Subject: Public Hearing Plans

**RE: PUBLIC HEARING TO BE HELD IN MANATEE COUNTY ON
PINEY POINT PHOSPHATES' SULFURIC ACID PLANT PERMIT**

Subject: Piney Point Phosphates, Inc.
Sulfuric Acid Plant
AC 41-173305 and PSD-FL-144

UPDATED INFORMATION FOR PSD REVIEW
OF SULFURIC ACID PLANT PROJECT

FIGURE 3-1

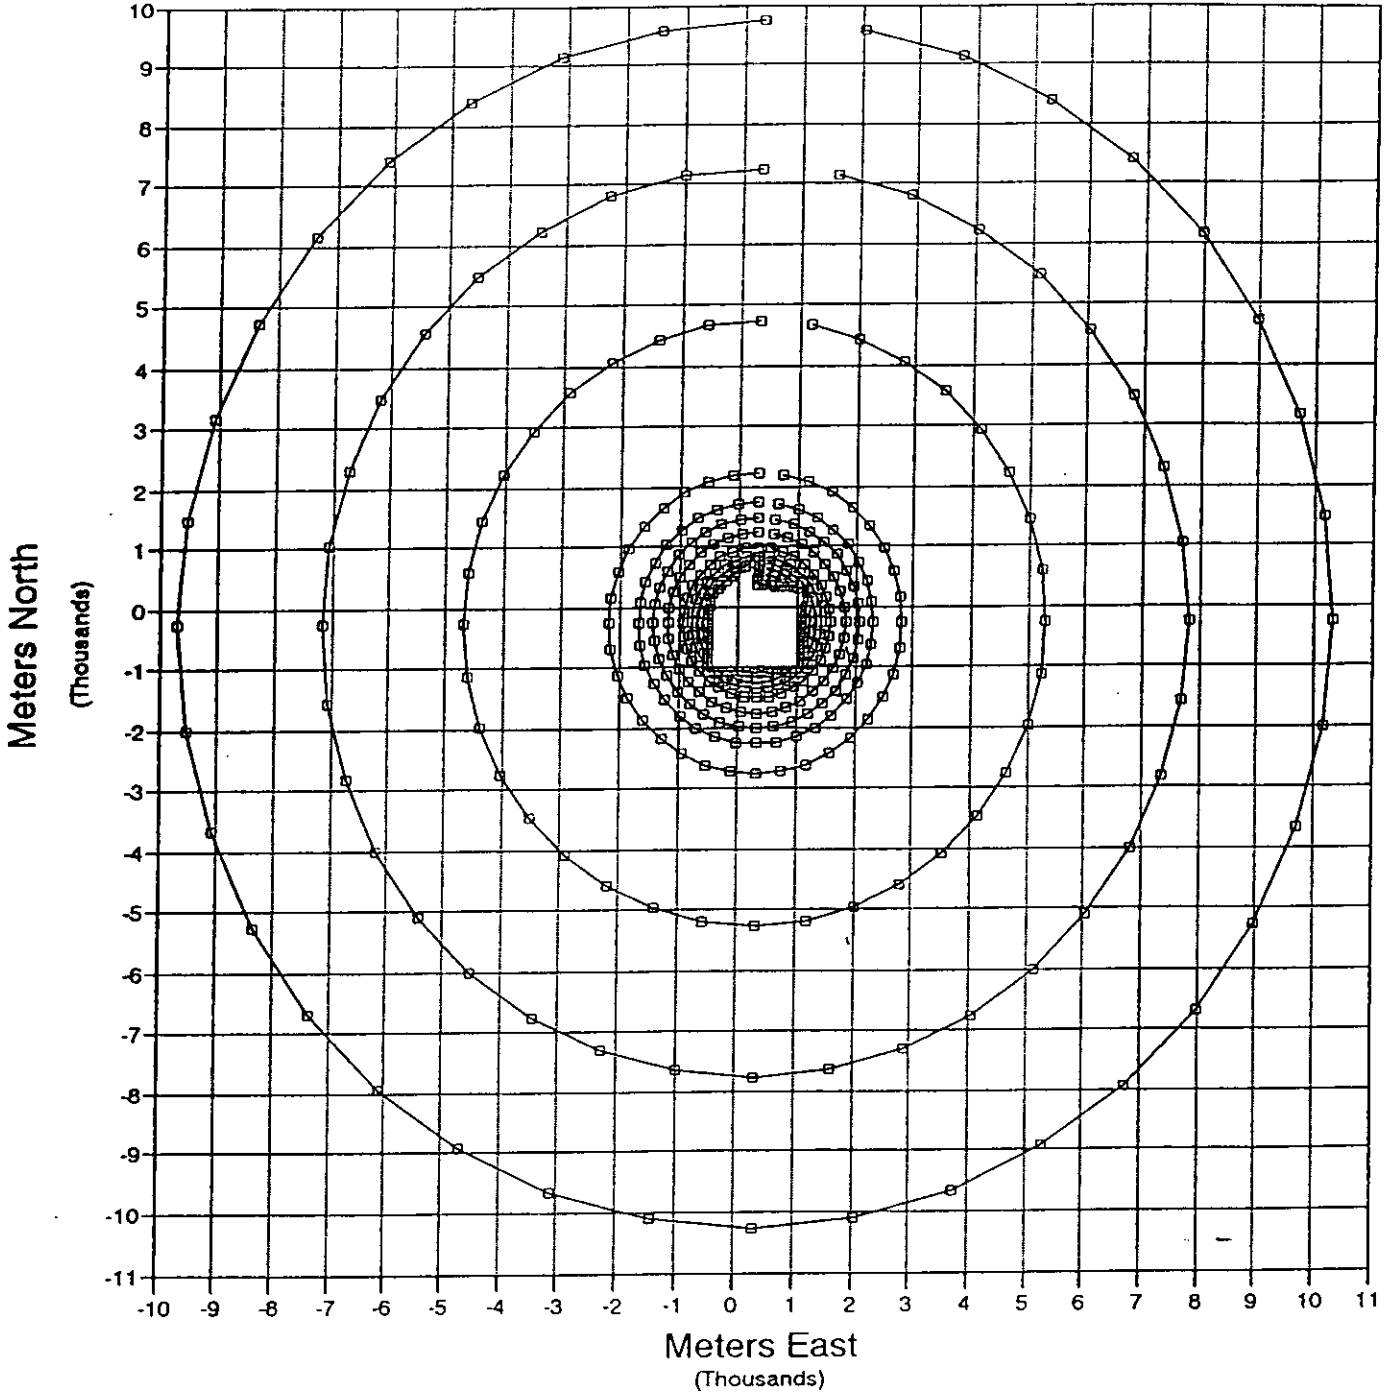
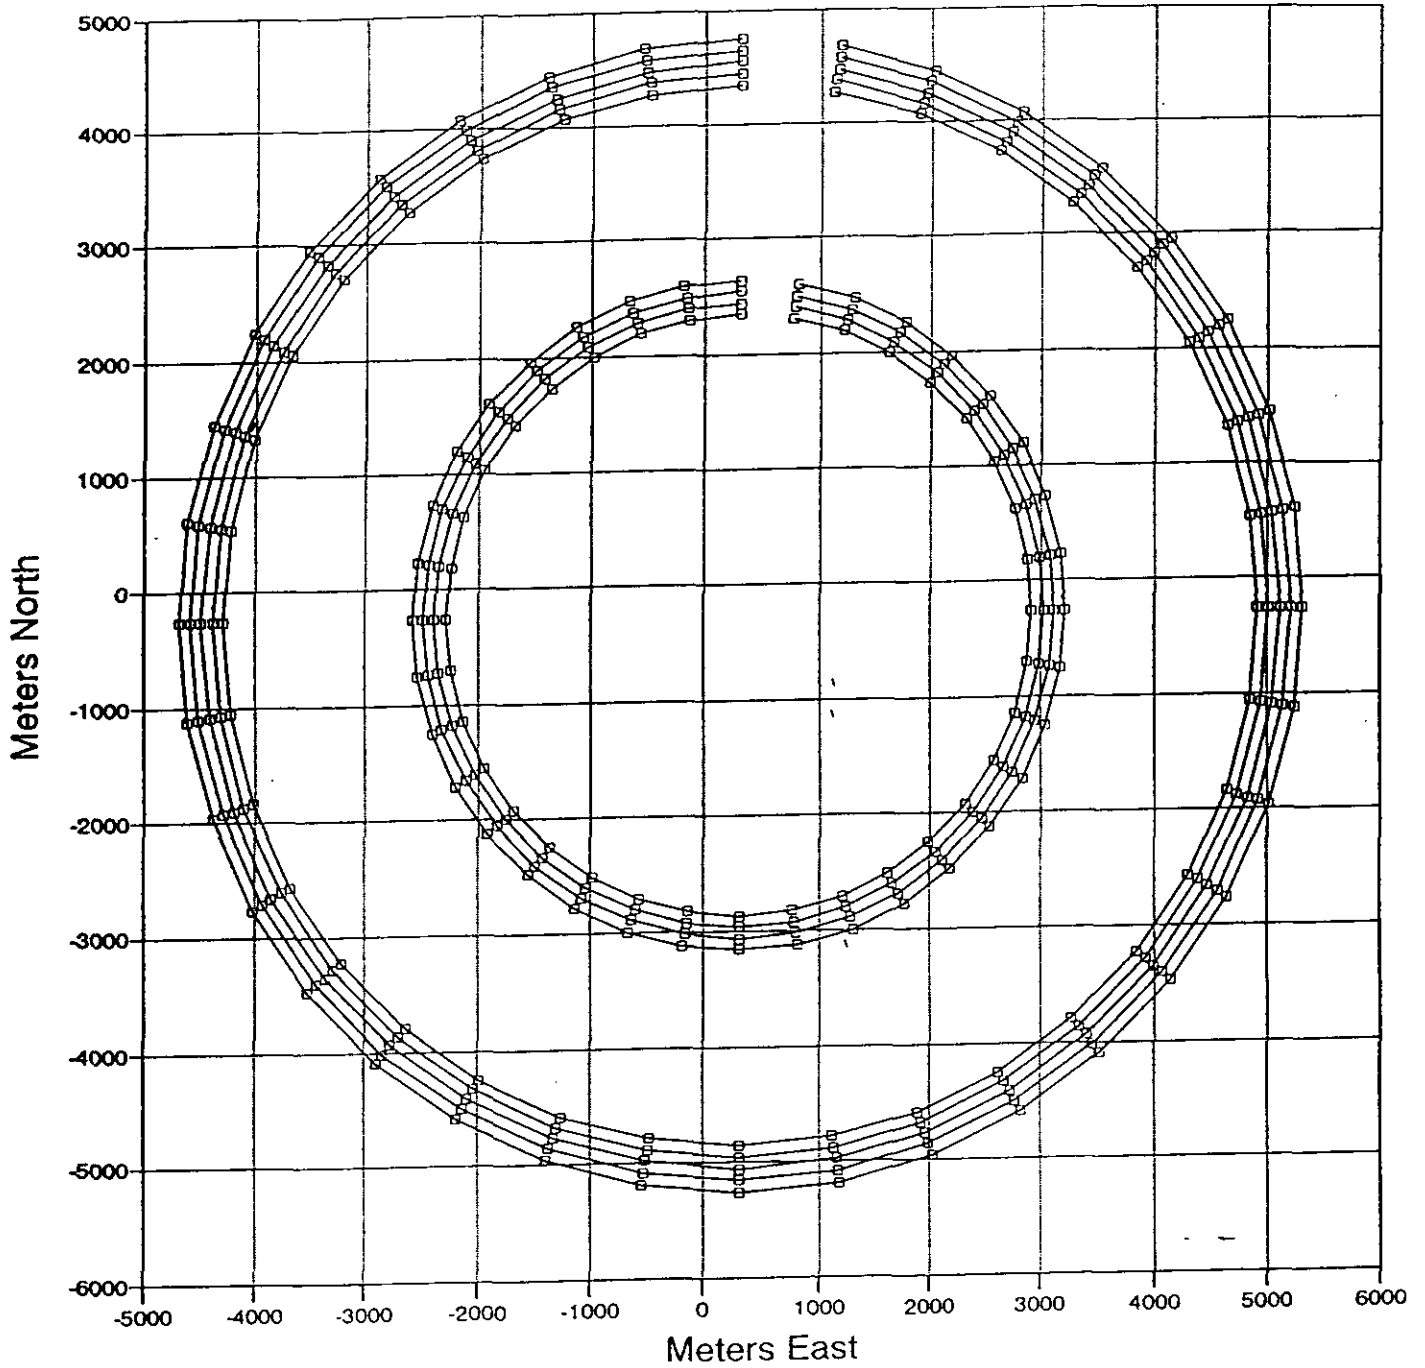
2. The annual area of significant impact modeling should be based on the difference between the proposed emissions and the actual annual hourly emissions. Please redo the annual area of significant impact modeling using the correct inputs.

1. Your response to the attached comments from the National Park Service.
2. The annual area of significant impact modeling should be based on the difference between the proposed emissions and the actual annual hourly emissions. Please redo the annual area of significant impact modeling using the correct inputs.

The sulfur dioxide air dispersion modeling for the significant impact analysis (SIA) has been updated for the annual period, as requested by FDEP. The emission rates representing the actual emissions for the existing sulfuric acid plants and the proposed emissions from the subject project were used in the modeling, in accordance with Table 9-1 in the Guidelines on Air Quality Models (Revised), EPA-450/2-78-027R, to determine the net ambient air impacts from the proposed project. As prescribed by the modeling guidelines, an operating factor representing the most recent two years of operation, was used in the analysis. The modeling inputs for the annual period and the results of the SIA modeling are summarized in Attachment 2. The results of the revised SIA modeling analysis indicate a significant impact for the annual period within the Class II area, and a less than significant impact at the Class I area. The area of significant impact for the annual period is less than the area evaluated previously for the 3-hour and 24-hour averaging periods. Further analysis indicates that the proposed project will be in compliance with the ambient air standards and allowable Class II area increment for the annual period (see Attachment 3). Consequently, the results do not change the ultimate outcome of the previously submitted ambient air quality standards analysis. The revised modeling information is provided on disk (enclosed).

extending to 10 kilometers from the source. The discrete receptors were placed along the property boundary at 100 meter intervals. The polar grid receptor rings were placed at distances ranging from 1250 to 10,000 meters from the plant with receptors placed at 10 degree intervals from 10° to 360° on each receptor ring, with the exclusion of receptors within the facility property boundary. The downwind receptor distances were selected in order to provide a higher concentration of receptors closer to the source where the maximum impacts were expected. Modeling was also conducted using receptors located at the nearest Class I area; Chassahowitzka National Wildlife Refuge. The receptor locations in the vicinity of the plant are shown in Figures 3-1 and 3-2.
